MDT Electronics

3x8 Signal HH Changes for Endcap Chambers

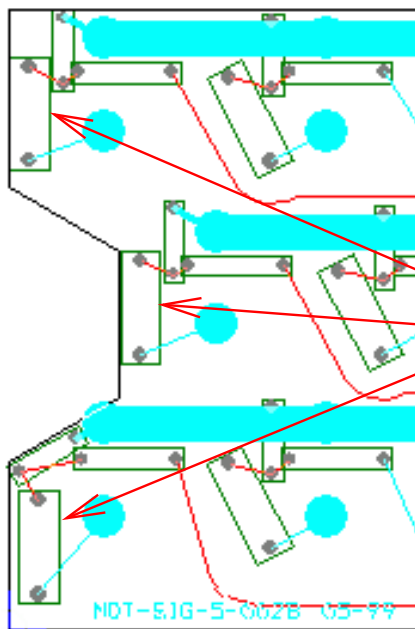
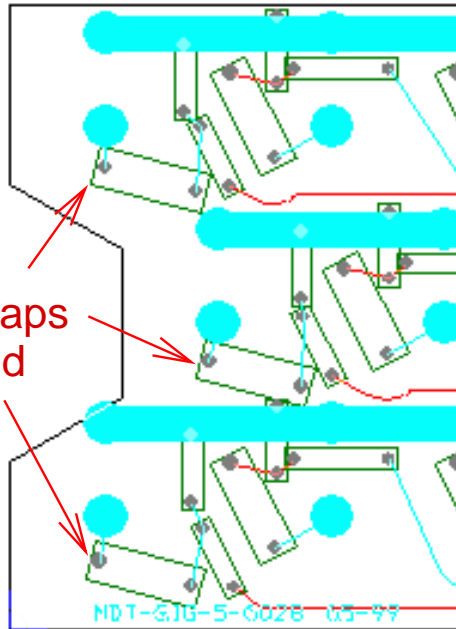
Layout Changes done... awaiting capacitor decision before prototyping

HV Caps moved
